METROPOLITAN GOVERNMENT OF NASHVILLE AND DAVIDSON COUNTY

STAFF RECOMMENDATION
522 Acklen Park Drive
July 18, 2012

Application: New construction-primary building and accessory structure
District: Richland-West End Addition Neighborhood Conservation Zoning Overlay
Council District: 24
Map and Parcel Number: 10405006400
Applicant: John Eldridge, E3 Construction Services LLC
Project Lead: Melissa Baldock, melissa.baldock@nashville.gov

<p>Description of Project: Construct new single-family residence and detached accessory structure on vacant lot.</p> <p>Recommendation Summary: Staff recommends approval of the project with the following conditions:</p> <ol style="list-style-type: none"> 1. Staff review and approve a brick sample, the asphalt shingle color, all window and door specifications, the material for the front porch floor and steps, the material for the rear deck and railing, and the design and material for any front porch railing; 2. The utilities be located in the rear of the house or along a side façade, beyond the midpoint of the house; and 3. The driveway be single-width to at least the front wall of the house, where it can expand to a double-width concrete driveway. <p>W

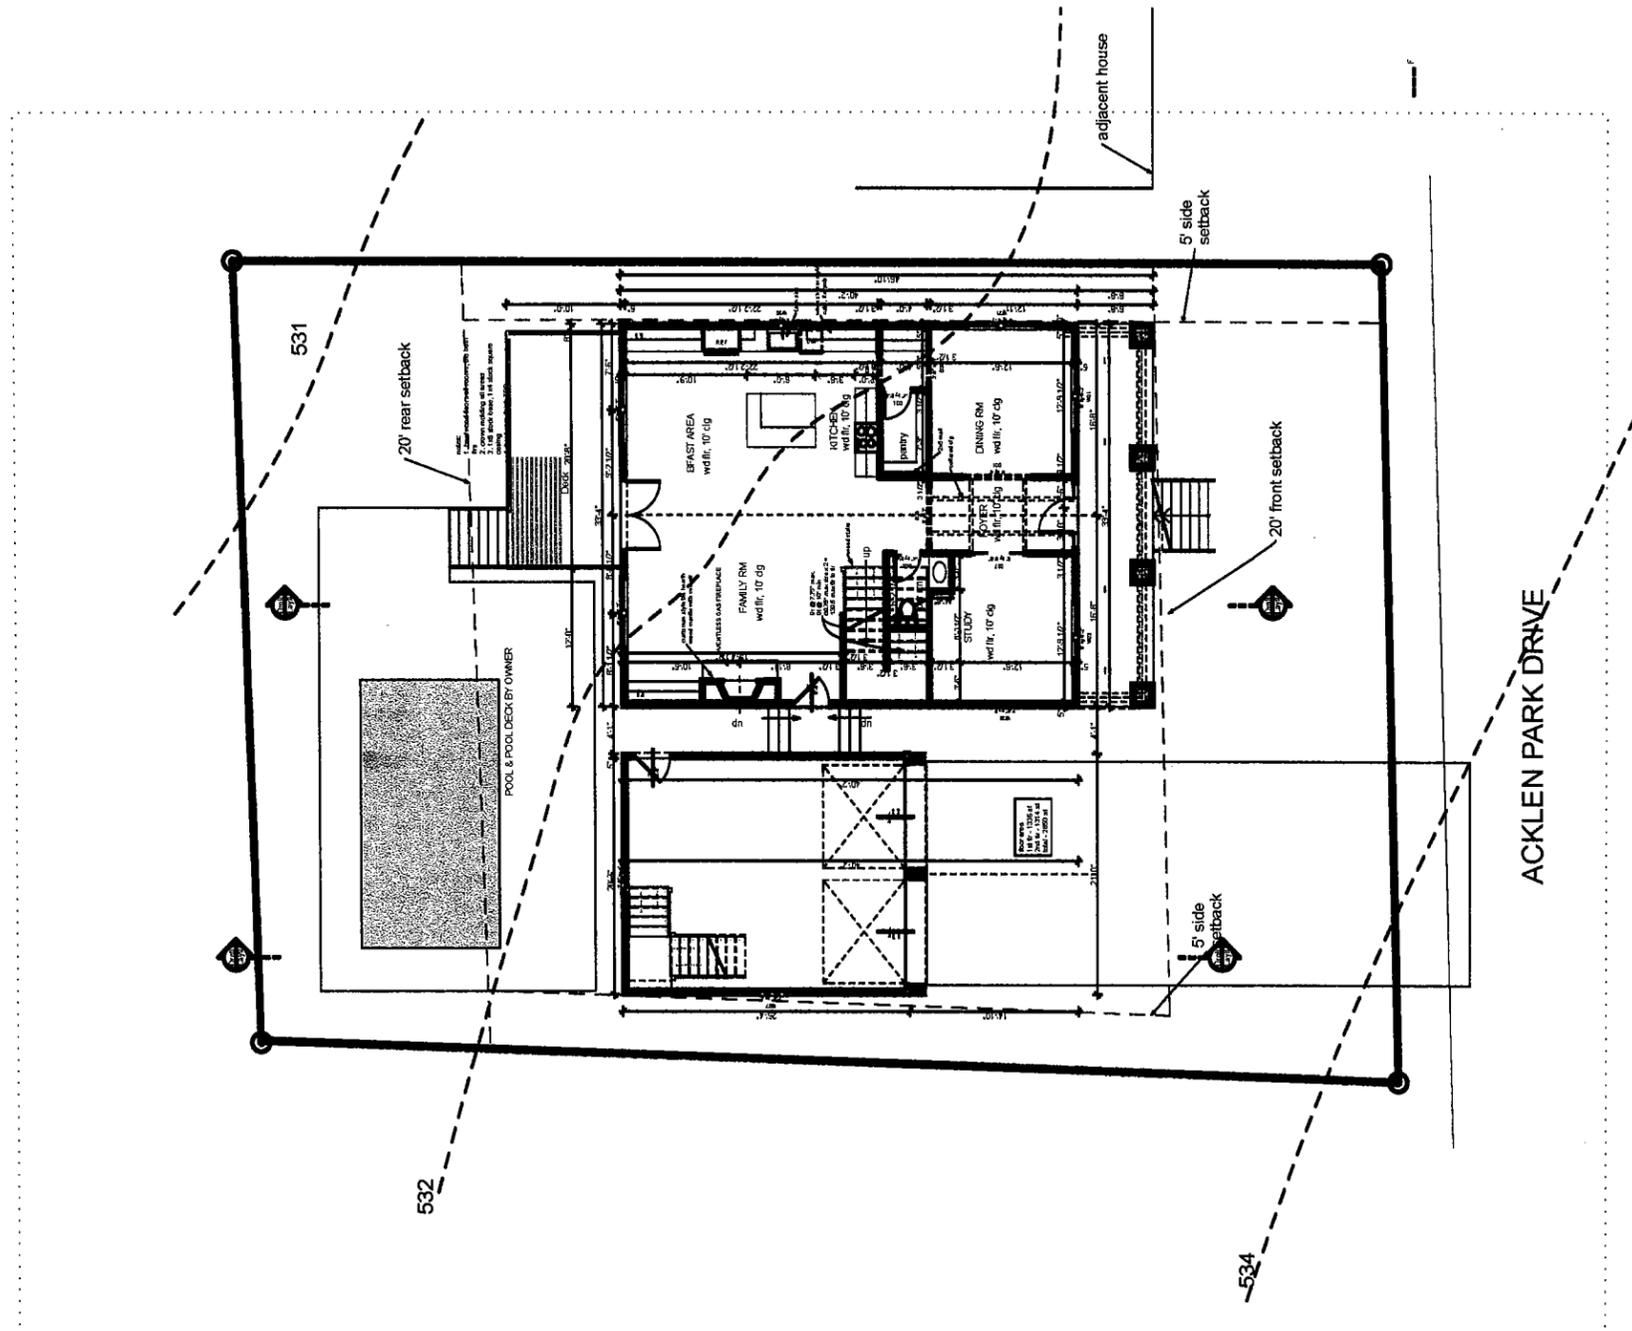
Outbuilding: As mentioned in the "Location and Setback" section, a garage is proposed to be located to the left side of the new primary structure, which staff finds appropriate in this instance. The garage doors will face Acklen Park Drive and will be accessed via a new curb cut, which staff finds appropriate since the site has no alley access. The garage will have two distinct bays and garage doors, which is appropriate when such a structure faces the street.

The garage will be approximately twenty-one feet (21') wide and twenty-seven feet (27') deep. It will have a ridge height of approximately twenty-one feet, ten inches (21'10") and an eave of approximately nine feet, two inches (9'2"). Both the ridge and the eave heights will be lower than those on the primary structure. The garage's roof form will be a side gable with a slope of 10/12. The front and back slopes will have shed dormers with slopes of 3/12. The materials for the garage will be similar to the materials for the primary structure. The garage will be clad in cement fiberboard with a five inch reveal. The roof will be dimensional shingles, and the windows will be wood. The material of the garage doors was not specified, and staff asks to review and approve the doors prior to purchase and installation.

1
SITE PLAN
 SCALE: 1/16" = 1'-0"

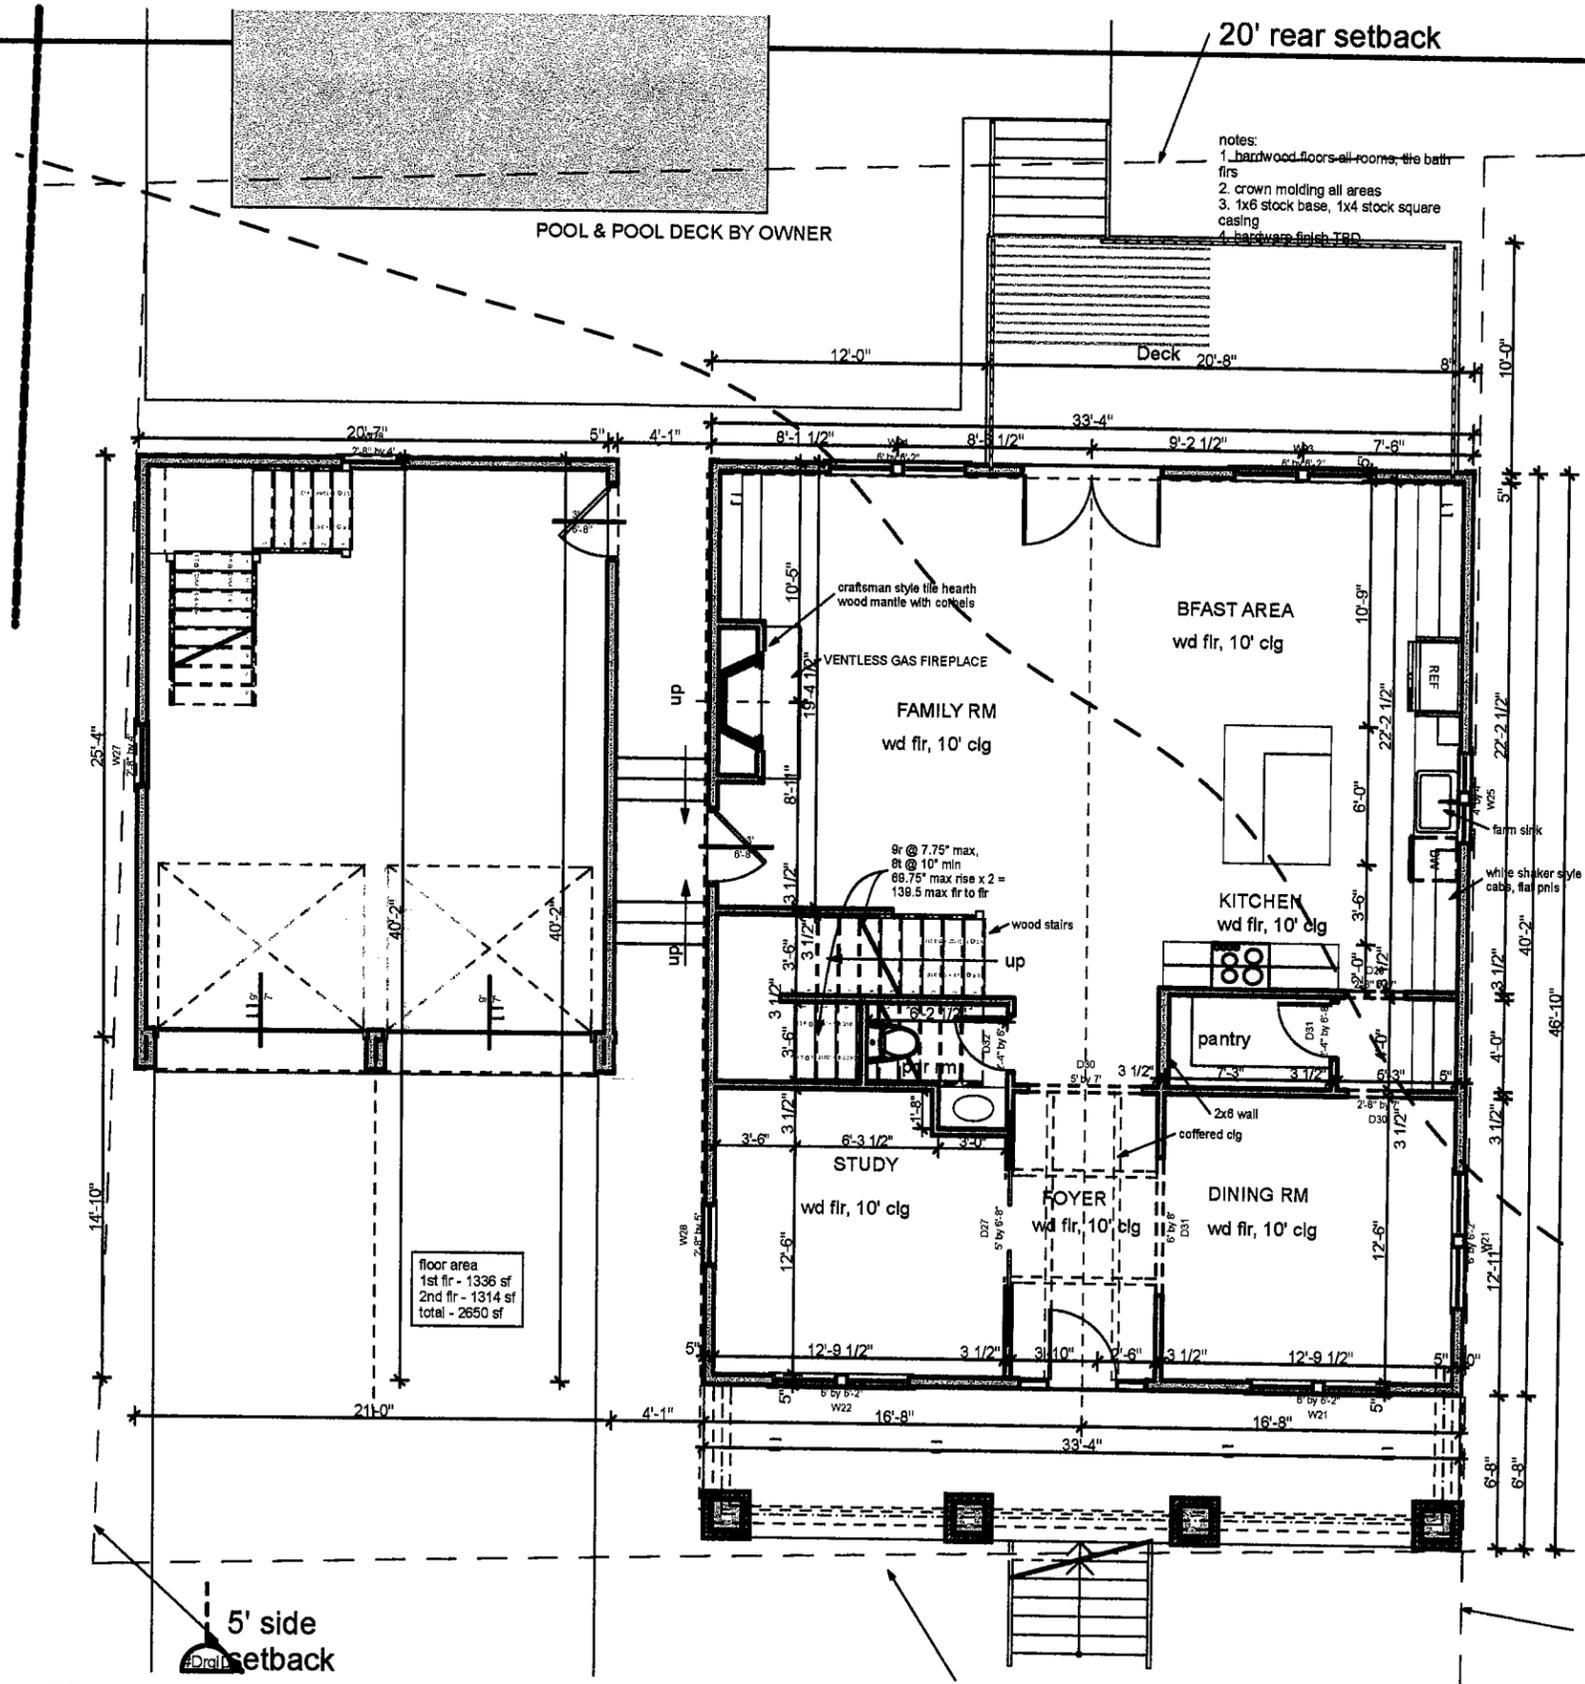
The primary building is situated towards the right/north side of the lot in order to accommodate the proposed accessory structure on the left/south side of the lot. The accessory structure, which will be discussed in detail under "Outbuildings," is detached, but located to the side of the proposed infill. The accessory structure's front wall is approximately thirteen feet, three inches (13'3") behind the front wall of the house and approximately nineteen feet, eleven inches (19'11") behind the line of the porch. The back wall of the accessory structure lines up with the back wall of the house. The accessory structure is separated from the house by a width of four feet, one inch (4'1").

Appurtenances: The site plans shows a double-width driveway leading to the garage. Double width driveways are not typically found in the historic Richland-West End neighborhood. Staff therefore asks that a condition of approval be that the driveway be single-width to at least the front wall of the house, where it can expand to a double-width concrete driveway. The pool shown on the site plan is not reviewed in a Neighborhood Conservation Zoning Overlay. No other appurtenances were indicated on the site plan, and staff asks to review and approve any other appurtenances before they are installed.

1. Staff review and approve a brick sample, the asphalt shingle color, all window and door specifications, the material for the front porch floor and steps, the material for the rear deck and railing, and the design and material for any front porch railing.
2. The utilities be located in the rear of the house or along a side façade, beyond the midpoint of the house.
3. The driveway be single-width to at least the front wall of the house, where it can expand to a double-width concrete driveway
